U.S. NUCLEAR REGULATORY COMMISSION

No. 50-255/96006(DRS)

Palisades Nuclear Generating Plant

Enforcement Conference on June 21, 1996 (Report No. 50-255/96006(DRS))

VIOLATION 1 - EXAMPLE 1: DIAGRAM OF IMPACTED FIRE AREAS

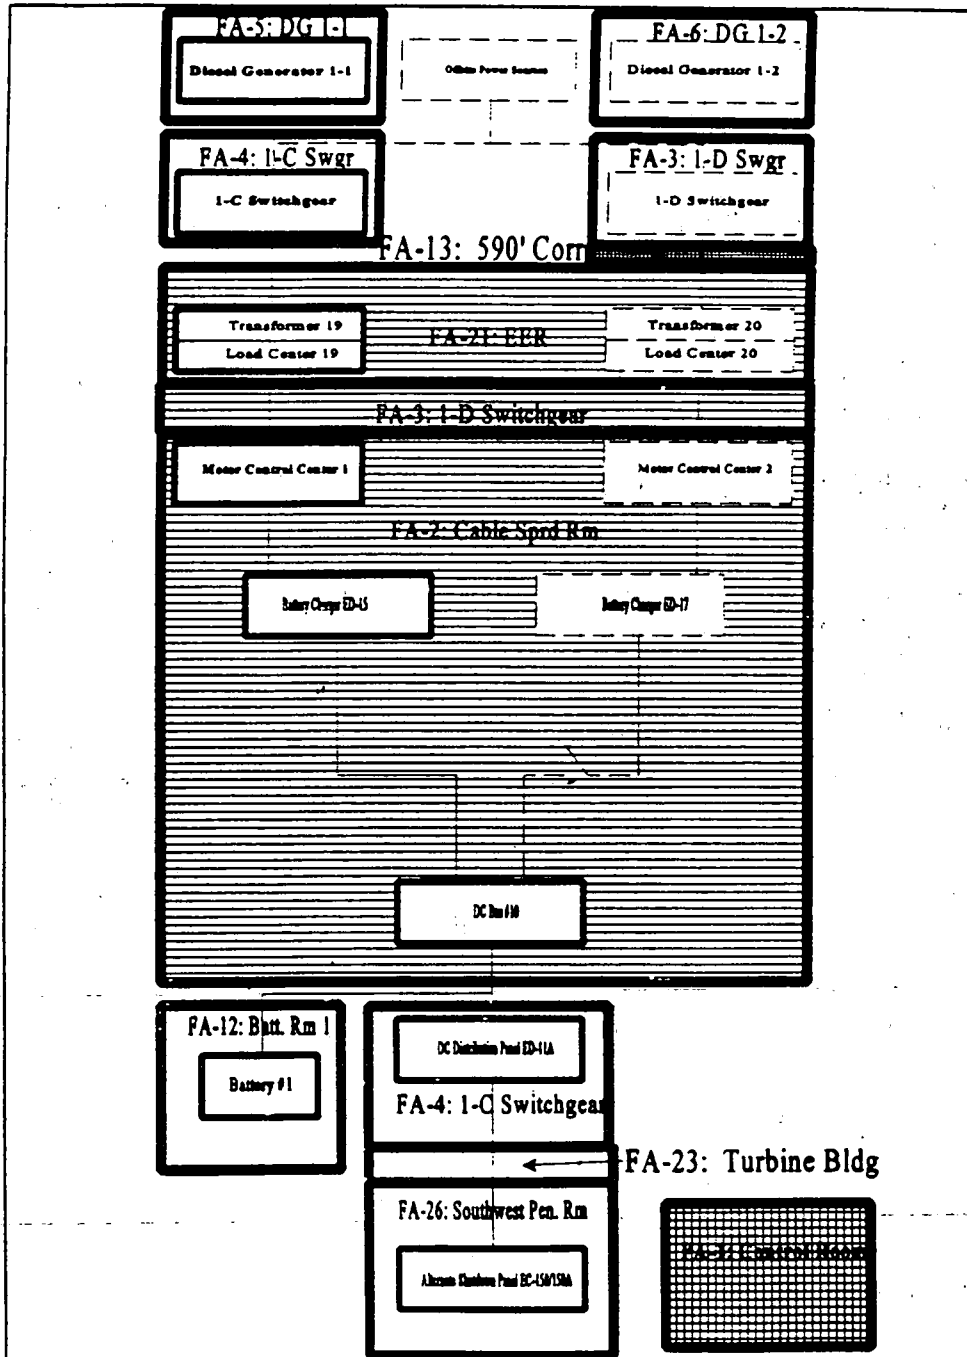
- EXPLANATION OF "NORMAL" SHUTDOWN USING ALTERNATE SHUTDOWN PANEL AND DESCRIPTION OF CONFIGURATION (SEE OUTLINE OF ACTIONS AND DIAGRAM ON FOLLOWING THREE PAGES)
- INOPERABLE INVERTER DISCOVERED IN SEPTEMBER 1995 DURING SURVEILLANCE TEST
- CAUSED BY FAILED ALARM BOARD
 - REPLACED WITHIN 7-DAY LCO PERIOD
 - REPLACEMENT LOW VOLTAGE CUT-OFF SET TO MINIMUM
- DID NOT RECOGNIZE FIRE PROTECTION SIGNIFICANCE OF FAILURE FOR PAST OPERABILITY OF THE INVERTER. CPCO DISCARDED FAILED BOARD AFTER TAKING SEVERAL READINGS (DISCUSSED LATER)
- IN JANUARY 1996, CPCO UNCOVERED "OPERABILITY" ISSUE DURING SYSTEMATIC REVIEW
- REPORTED CONDITION IN LER 96-003. LER NOTED THAT:
 - INVESTIGATION CONTINUING
 - LOW VOLTAGE SET POINT MAY HAVE BEEN INCORRECTLY SET, POTENTIALLY CAUSING LOSS OF ALTERNATE SHUTDOWN PANEL DURING CERTAIN FIRES

VIOLATION 1 - EXAMPLE 1: FAILED INVERTER "READINGS"

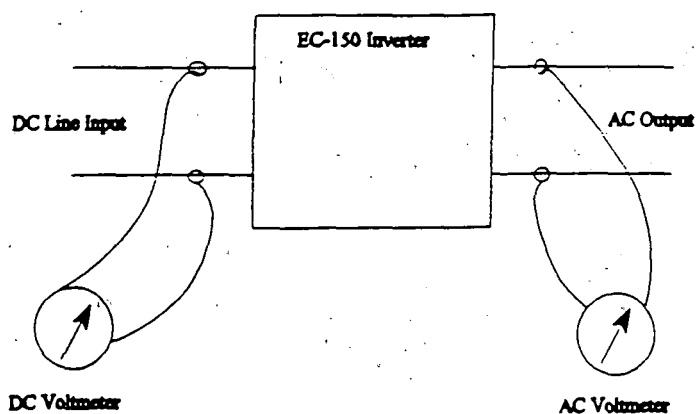
- CAUSE OF C-150 PANEL FAILURE WAS DEFECTIVE INVERTER ALARM LOGIC BOARD. BOARD WAS REPLACED AS A UNIT
- INPUT VERSUS OUTPUT READINGS WERE TAKEN ON THE FAILED INVERTER AND SEEMED TO INDICATE A LOW VOLTAGE CUT-OFF AT 120 VDC (SEE DIAGRAM ON PAGE 13)

- HOWEVER, INVERTER VENDOR STATED "A DETERMINATION OF THE ORIGINAL LOW VOLTAGE CUT-OFF SET POINT CANNOT RELIABLY BE MADE, WHILE ADJUSTING THE INPUT VOLTAGE TO THE INVERTER AND MEASURING THE INPUT VOLTAGE LEVEL AT WHICH THE INVERTER SHUTS DOWN, IF THE ALARM LOGIC BOARD INSTALLED IN THE INVERTER IS DEFECTIVE."
- THEREFORE, THE MEASURED INVERTER CUT-OFF VOLTAGE DOES NOT PROVIDE RELIABLE INDICATION OF THE TRUE LOW VOLTAGE CUT-OFF SET POINT

VIOLATION 1 - EXAMPLE 2: DIAGRAM OF EDG CONFIGURATION

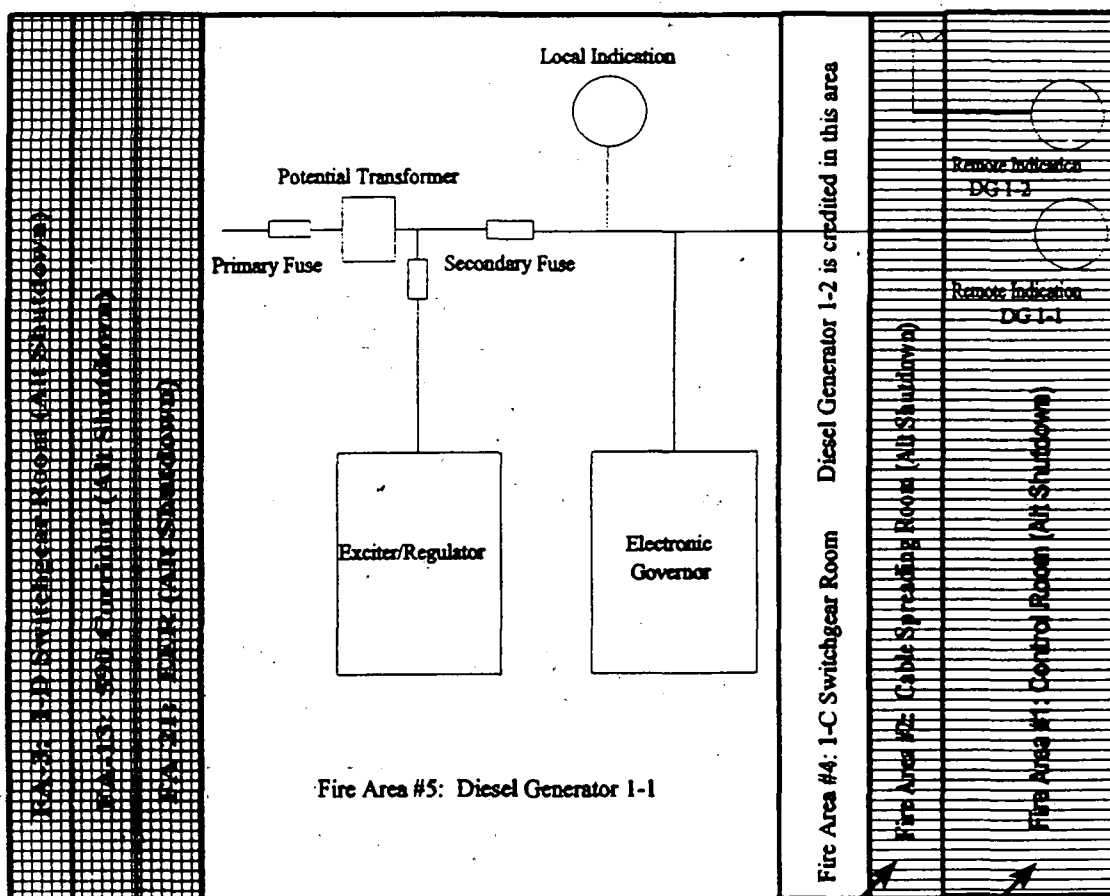
- DESCRIPTION OF CONFIGURATION (SEE DIAGRAM ON FOLLOWING PAGE)
- PROBLEM WAS IDENTIFIED IN NOVEMBER 1995 BY CPCO DURING REVIEW OF ASSOCIATED CIRCUIT ANALYSES
- REAFFIRMED PRESENCE OF COMPENSATORY MEASURES
- ALERTED OPERATORS TO CONDITION
- REPORTED CONDITION TO THE NRC IN LER 96-013

A fire occurring in either of these two rooms could cause a loss of both DG1-1 and DG 1-2

- INITIAL APPENDIX R COMPLIANCE ISSUE — ORIGINAL APPENDIX R ANALYSIS DID NOT RIGOROUSLY VERIFY FULL COORDINATION
 - CORRECTIVE ACTION AND SCHEDULE:
 - NEW CALCULATION PERFORMED

- WHILE TRAINING WAS PROVIDED TO OPERATORS, MORE PERMANENT MEASURES (E.G., PROCEDURE CHANGE) NOT TAKEN WHILE MOD WAS PENDING — IMPACTED BY FIRE TOUR "MIND SET"
 - CORRECTIVE ACTIONS AND SCHEDULE:
 - REINFORCED TO OPERATORS THE GUIDANCE PREVIOUSLY GIVEN
 - ACCELERATED MODIFICATION COMPLETION
 - REVIEWED ALL OUTSTANDING CONDITION REPORTS TO ASSURE ADEQUATE COMPENSATORY MEASURES

- FAILURE TO ACCELERATE FUSE REPLACEMENT IN VIEW OF THE POTENTIAL SAFETY SIGNIFICANCE — IMPACTED BY FIRE TOUR "MIND SET"
 - CORRECTIVE ACTION AND SCHEDULE:
 - FUSE REPLACED ON JUNE 3, 1996 (ACCELERATED FROM JULY 1996)
 - REVIEWED ALL OUTSTANDING CORRECTIVE ACTIONS FOR ACCELERATION POTENTIAL (3 ACCELERATED)
